CEN-268, REVISION 1  
SUPPLEMENT 1-NP, REVISION 1-NP

**RESPONSE TO NRC REQUEST  
FOR ADDITIONAL INFORMATION  
ON CEN-268**

PREPARED FOR THE C-E OWNERS GROUP BY  
TRANSIENT METHODS AND LOCA GROUP  
NUCLEAR FUEL ENGINEERING

MAY 1987

FIGURE 7

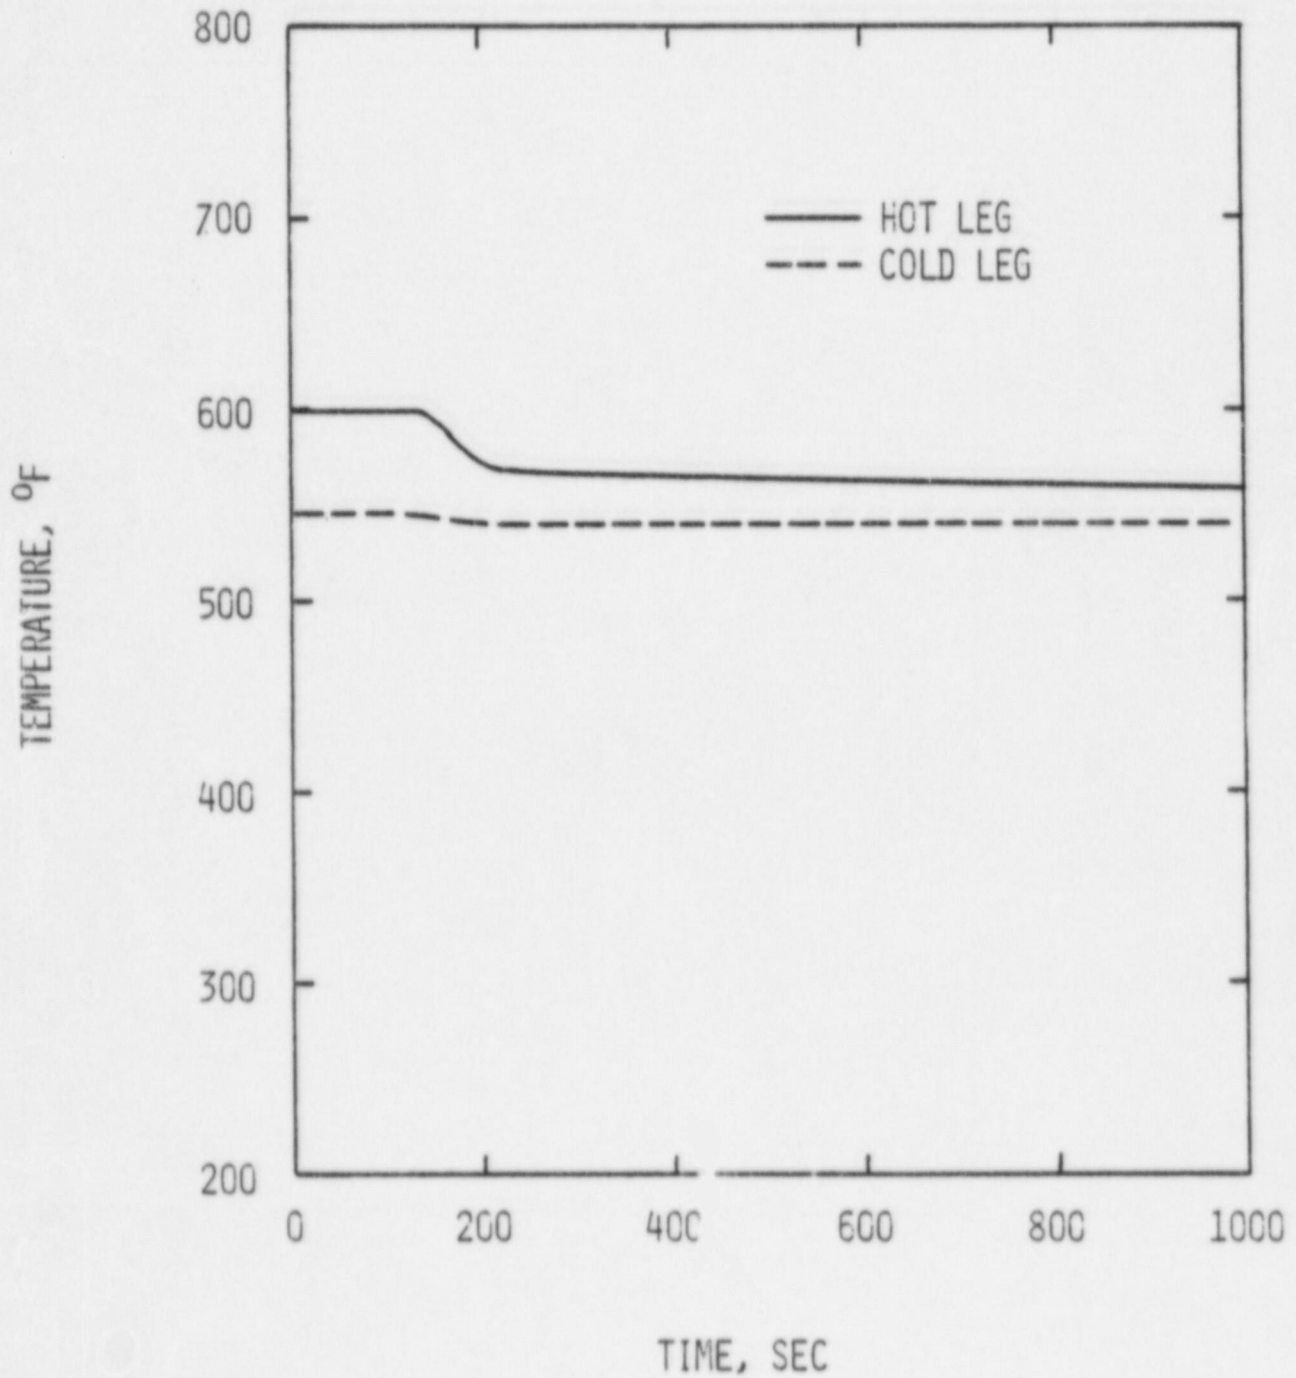
Question 27: In reference to the plots for the inadvertent open PORV analysis, why do the hot and cold leg temperatures remain almost constant for the entire transient?

Question 29: In reference to the inadvertent open PORV analysis, clarify why the subcooling does not go to zero earlier when the pressure drops below 1543 psia.

Response: The figure in question was mislabeled and is not representative of an inadvertent open PORV transient. The hot and cold leg temperatures provided in Figure 5-6 are representative of a much smaller break size than an open PORV and a transient which does not result in RCS depressurization. The hot and cold leg temperatures consistent with the other plots for the inadvertent open PORV analysis are provided in Figure 7. Note that the hot leg temperature decreases rapidly after reactor trip and saturation is reached at about 240 sec.

Response: As stated in the response to question 27, the temperature plots provided in Figure 7 are consistent with the loss of subcooling shown in Figure 5-7 and the other plots for the inadvertent open PORV analysis. Based on the temperature data given in Figure 7, the hot leg subcooling would not be expected to go to zero before about 240 sec, as shown in Figure 5-7. For further clarification, the hot leg loss of subcooling for the inadvertent open PORV analysis is presented in Figure 8 on an expanded time scale.

FIGURE 9  
2700 MW<sub>T</sub> PLANT ANALYSIS  
0.1 FT<sup>2</sup> HOT LEG BREAK LICENSING ANALYSIS  
BREAK FLOW

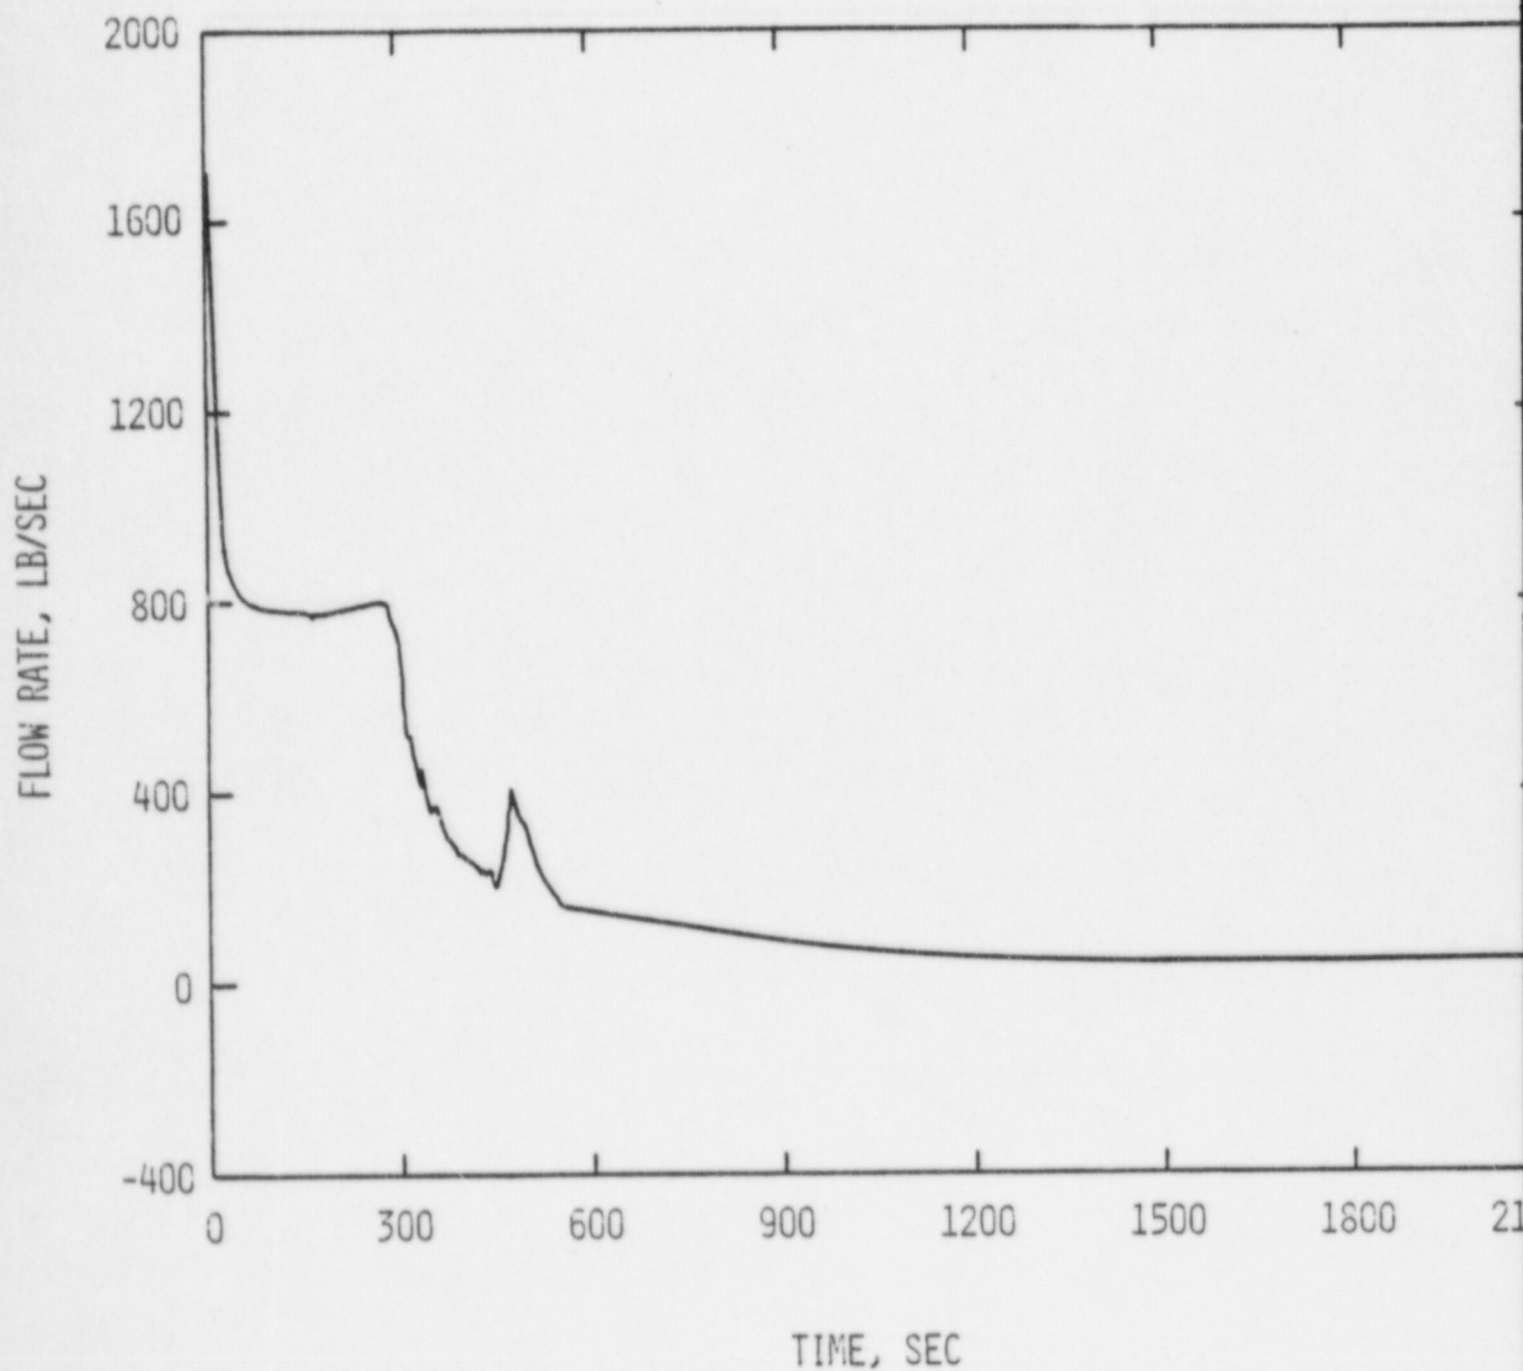
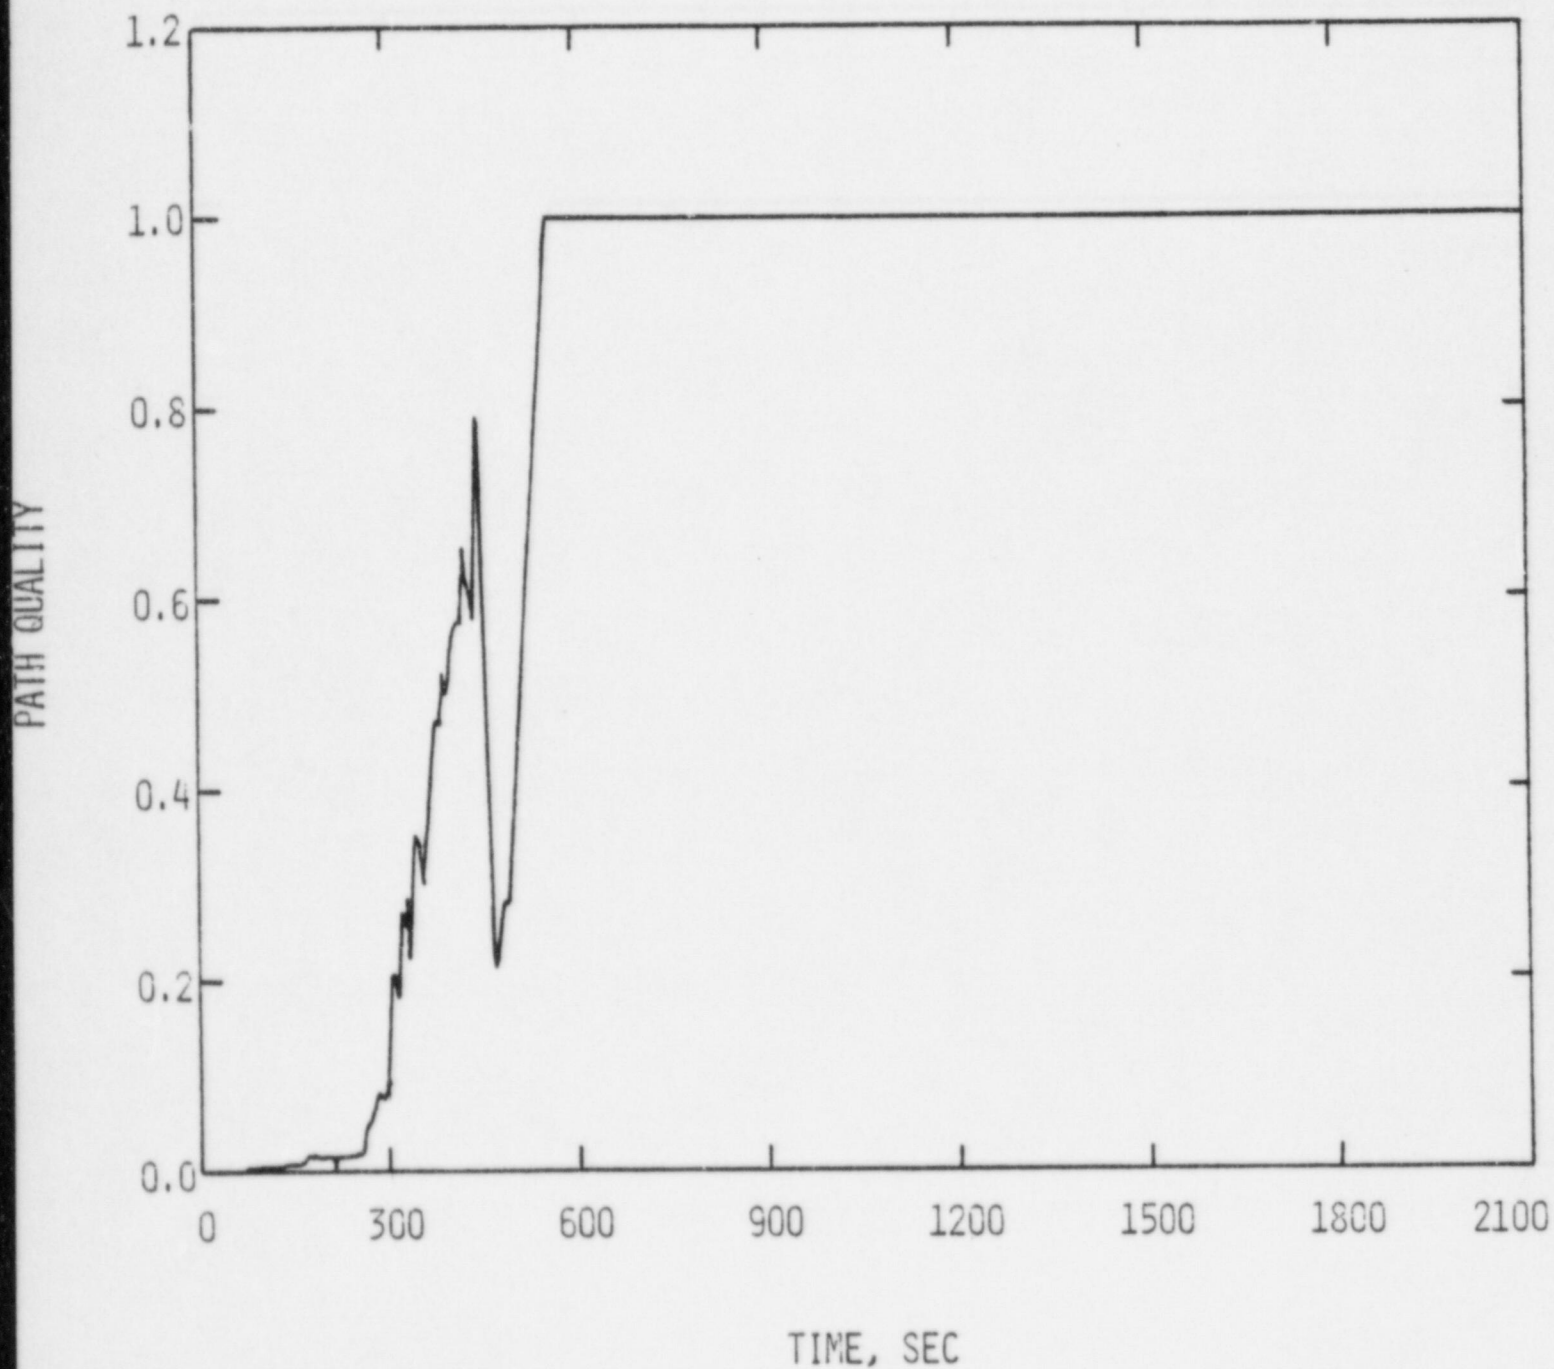
Question 45: Provide plots of the break flow and void fraction in the hot leg near the break for the licensing analysis case discussed in Section 7.1.

Response: As was agreed at the October 4, 1984 meeting, plots of break flow and quality near the break would provide an acceptable response to this question. These plots for the 0.1 ft<sup>2</sup> hot leg break licensing analysis are provided in Figures 9 and 10, respectively.

FIGURE 11  
SELOCA NODING DIAGRAM: USED IN  
CEFLASH-4AS FOR RCP TRIP ANALYSES

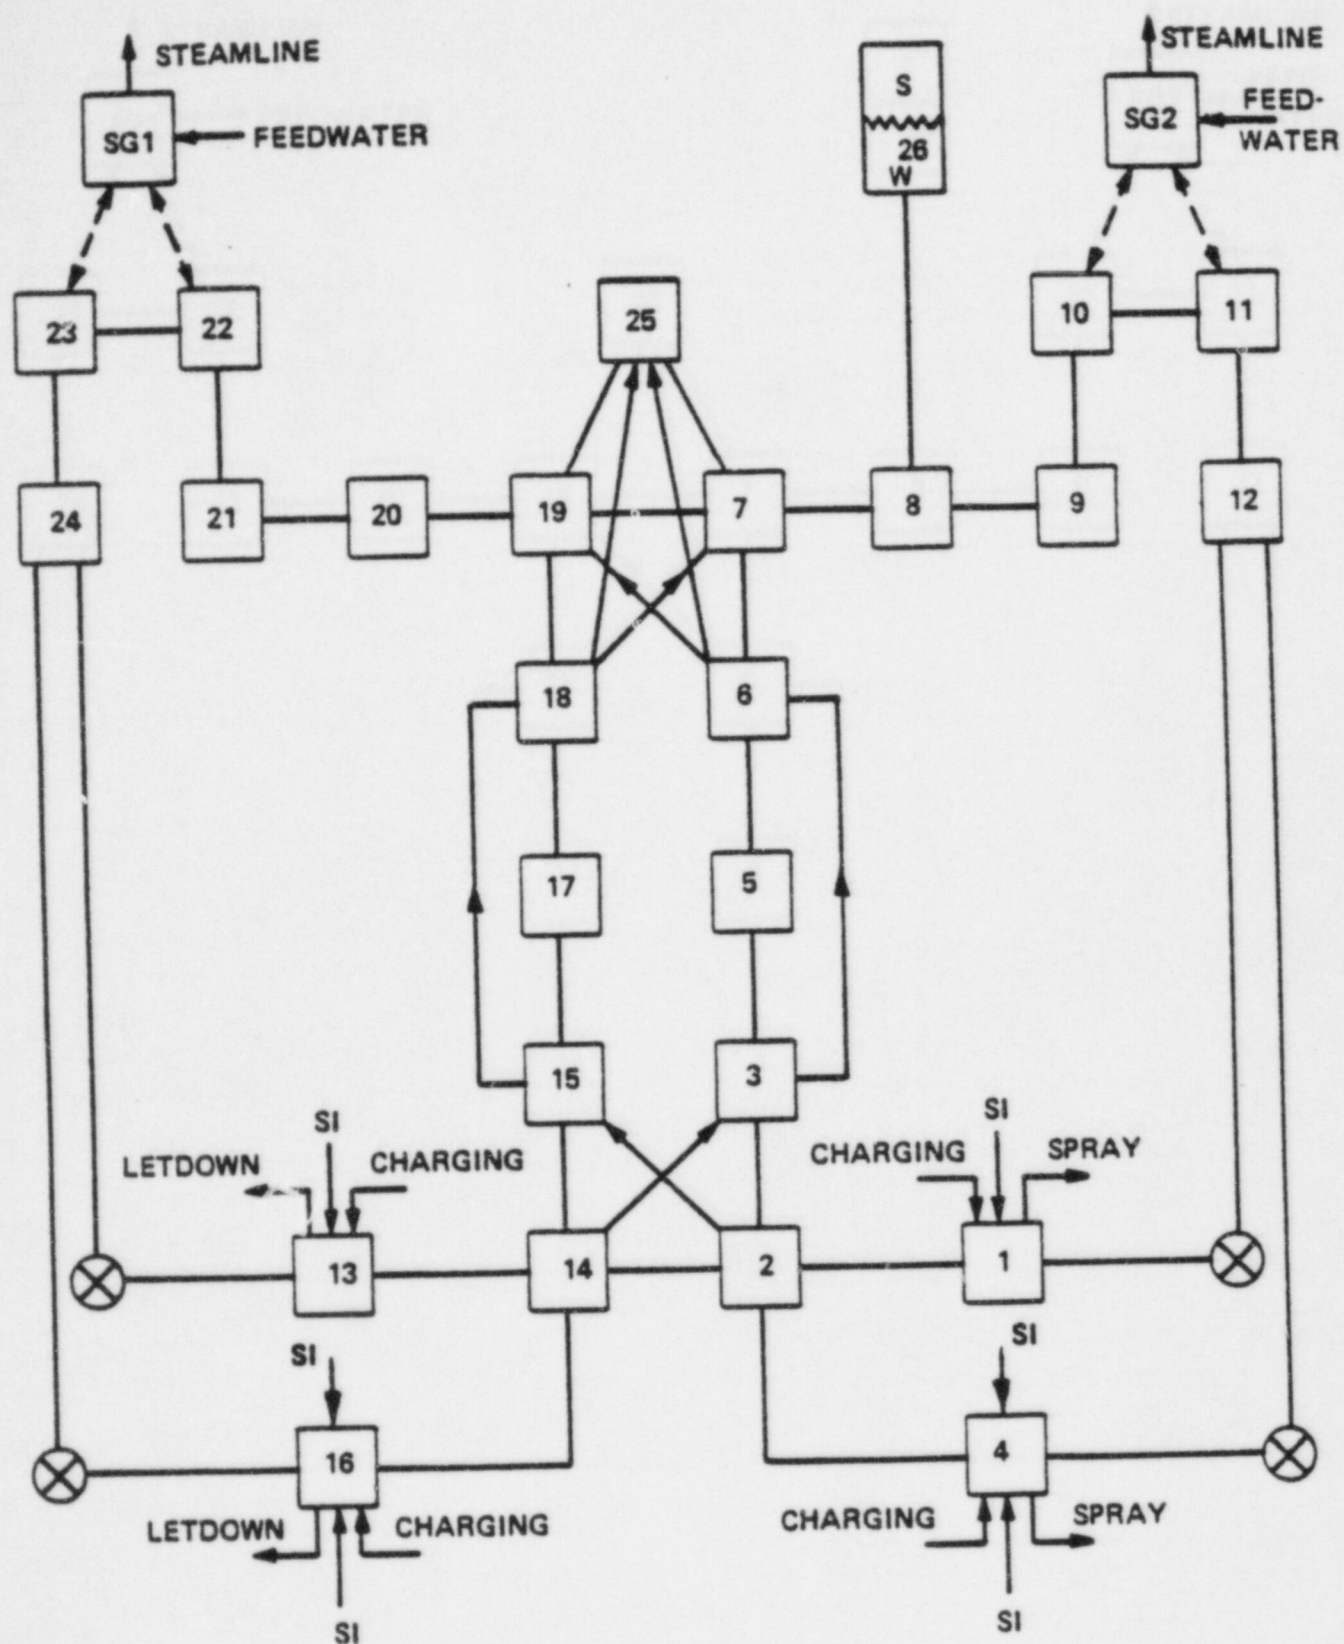
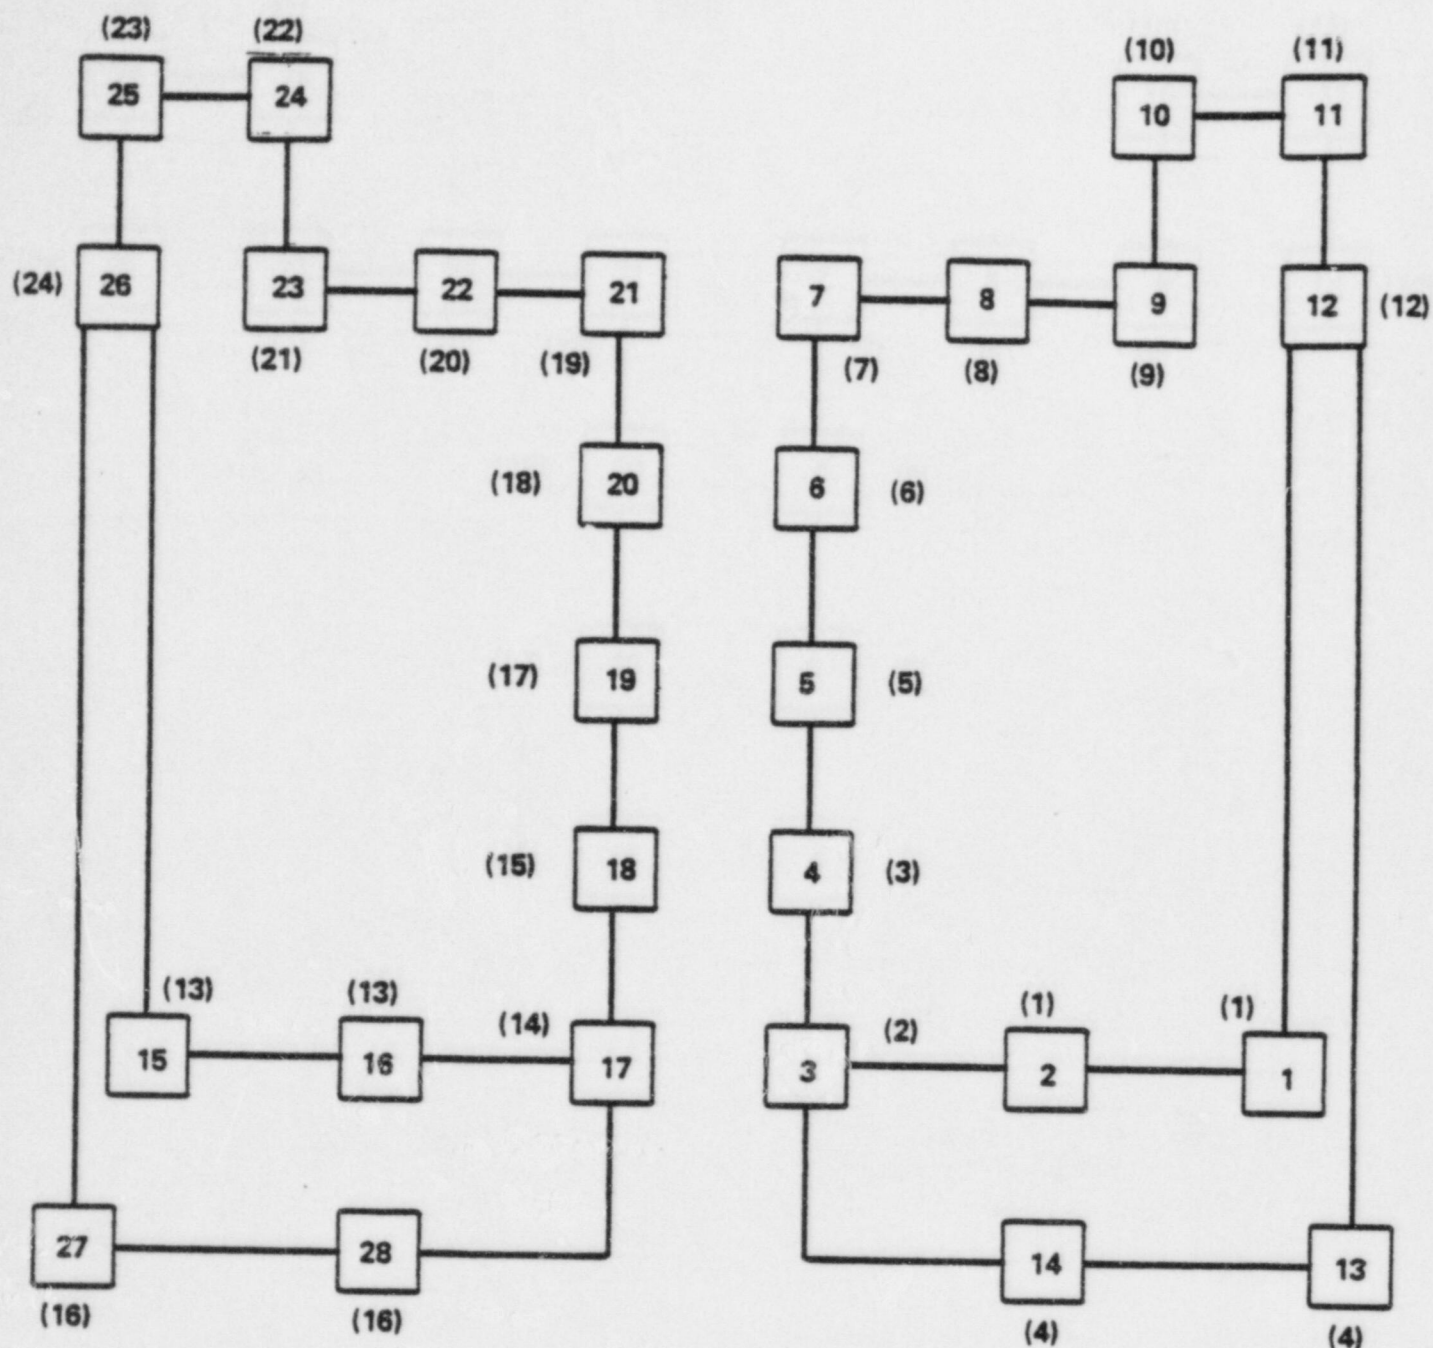
Question 58: Clarify with system noding diagrams what models were used for each of the transients discussed.

Response: A best estimate CEFLASH-4AS system model was used for the SBLOCA analyses. The CEFLASH-4AS node and flow path diagram is provided in Figure 11.
